**Our Reference: J6963**

**Response to Request for Further Information- 10.2021.698.1**  
**Reflections Holiday Park Coastal Protection Works, Clarkes Beach, Byron Bay**

## **Geobag works fronting Clarkes Beach Café and Reflections Holiday Park, Byron Bay**

**Figure 1: Seawall end effect variables (Figure 7.3 in WRL, 2021)**

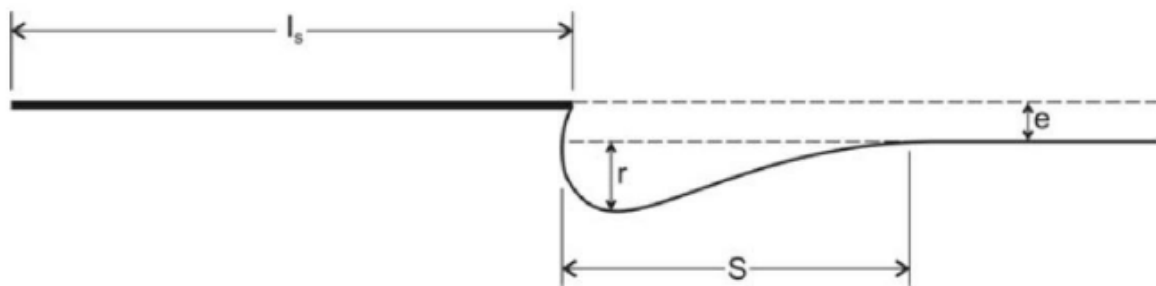
*Council acknowledges that you have supplied coastal engineering advice on the likelihood and consequence of an "end effect" near the immediate western end of the geobag structure.*

*Can you please provide specific coastal engineering advice as to the potential impacts of the geobag structures on coastal land further along Main Beach and beyond over the proposed 5 year life of the development?*

End effects estimates were detailed in Table 7.2 of WRL (2021) using two techniques. The form of end effects is shown in Figure 1.
